Serial Number 10/743,938
Attorney Docket No. A3-239 US

AMENDMENTS TO THE DRAWINGS:

ANNOTATED MARKED UP DRAWINGS

FIG 9

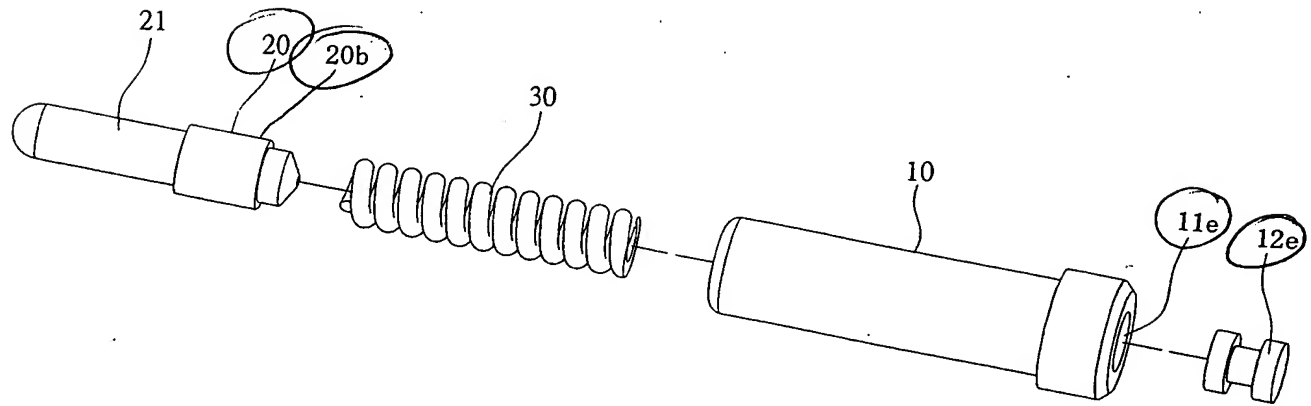
Figure 1 has been modified to show that the pin is in the prior art. Figures 5 - 10 and 12 have been modified by adding additional element numbers to make the drawings more consistent with the specification and claims.

Figure 1 was changed to show that it is in the prior art. Figures 5 - 10 and 12 have been changed with new element numbers to make the drawings consistent with the specification. Attached is a copy of five sheets of drawings which replace the drawings originally filed. Also attached are "Annotated Marked Up Drawings" which show the changes that have been made.
